Written submission from the Kebaowek First Nation

BWXT Medical Ltd.

Application for a Class IB nuclear substance
processing facility operating licence

Commission Public Hearing

Figure 1: BWXT Medical and Nordion licenced and leased areas

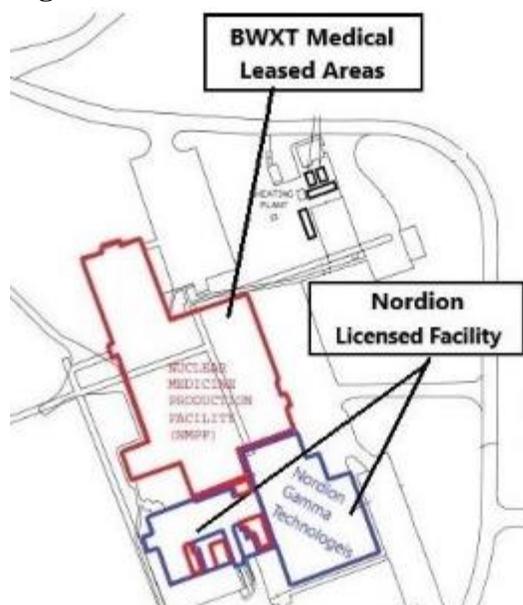
As described by CNSC Staff (see Figure 1 below), the proposed BWXT Medical licence would authorize BWXT Medical to operate the Nuclear Medicine Production Facility (NMPF), and the operation of this facility would be removed from Nordion’s Licence Conditions Handbook. Nordion would continue to operate the Cobalt Operations Facility (COF) only. CNSC Staff state “no licence amendment would be required.”⁵

However, these statements and the recommendation by CNSC Staff to grant the licence fails to consider significant operational changes at the site regarding the production of molybdenum-99 (Mo-99), that BWXT Medical is a first-time licensee, and the success of Nordion and BWXT Medical partnership remains to be seen. It is for these reasons, each detailed below, that Kebaowek strongly opposes a ten-year licence:

1. A significant change is proposed at the site which would allow BWXT Medical to produce molybdenum-99 (Mo-99) using neutron activation of natural molybdenum-98 targets in a reactor. The foregoing documentary and consultation omissions must be remedied before proceeding with any licence. A ten-year licence would be a further violation of the Indigenous and participatory rights which should be prioritized by the CNSC as Canada's nuclear regulator.

3. Nordion and BWXT Medical will share the oversight and compliance of a number of Safety and Control Areas. For reasons of different staff, leadership, company direction and internal management, the success of these shared responsibilities cannot be assumed. Further, of the shared responsibilities described by CNSC Staff (excerpted below), none are reflected in the proposed Licence of LCH with the same level of detail or clarity. It is critical they be expressly set out in the LCH. These areas of shared oversight include:
